Access Compliance Report

Public Rights-of-Way

Intersection ID: N/A	Main Street: PROVIDENCE_RD	Cross Street: N/A	Location: SW
ADA ID: 38E88BB74FB7	Ramp Type: PerpDiag	Initial Pass/Fail: Fail	Overall Compliance: No
		Severity Score: 22.5

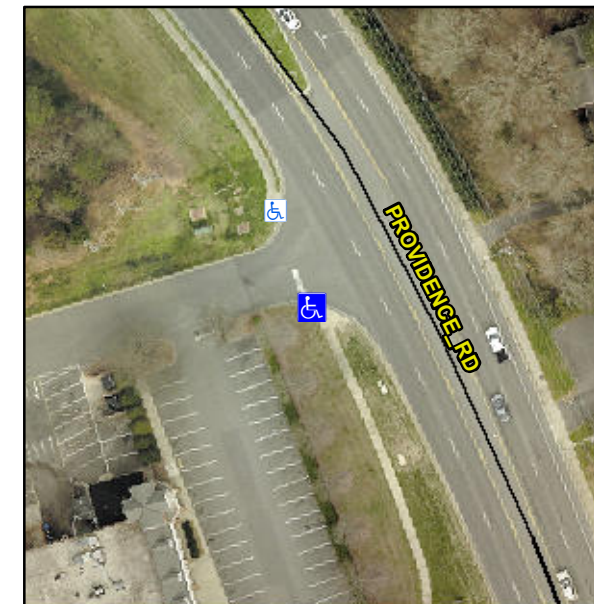
R304.5.1, R304.2.2, R304.5.3

Compliance	Description	Data	Compliance	Description	Data
N/A	Ramp Length (in)	84.0	No	Ramp Slope (%)	9.1
No	Ramp Width (in)	39.0	No	Ramp XSlope (%)	4.2
N/A	Flare Type LT	N/A	N/A	Flare Type RT	N/A
N/A	Flare Slope LT (%)	N/A	N/A	Flare Slope RT (%)	N/A
N/A	Flare Traversable LT?	N/A	N/A	Flare Traversable RT?	N/A
N/A	Landing Length (in)	N/A	N/A	DWS Provided?	N/A
N/A	Landing Width (in)	N/A	N/A	DWS Contrast?	N/A
N/A	Landing Slope (%)	N/A	N/A	DWS Length (in)	N/A
N/A	Landing X Slope (%)	N/A	N/A	DWS Full Width?	N/A
N/A	Landing Curb? (Y/N)	N/A	N/A	DWS Offset (in)	N/A
N/A	Shared Landing?	N/A			
N/A	Gutter Ponding?	N/A	N/A	Gutter Slope (%)	N/A
N/A	Gutter Lip Ht (in)	N/A	N/A	Gutter X Slope (%)	N/A
N/A	Painted X Walk1?	No	N/A	Painted X Walk2?	No
	X Walk 1 Direction	To E		X Walk 2 Direction	To N
N/A	X Walk 1 Width (in)	N/A	N/A	X Walk 2 Width (in)	N/A
	X Walk 1 Slope (%)	9.9		X Walk 2 Slope (%)	5.1
	X Walk 1 X Slope (%)	0.4		X Walk 2 X Slope (%)	8.5

Remove & Replace Curb Ramp With Two New Directional Ramps or Equivalent.
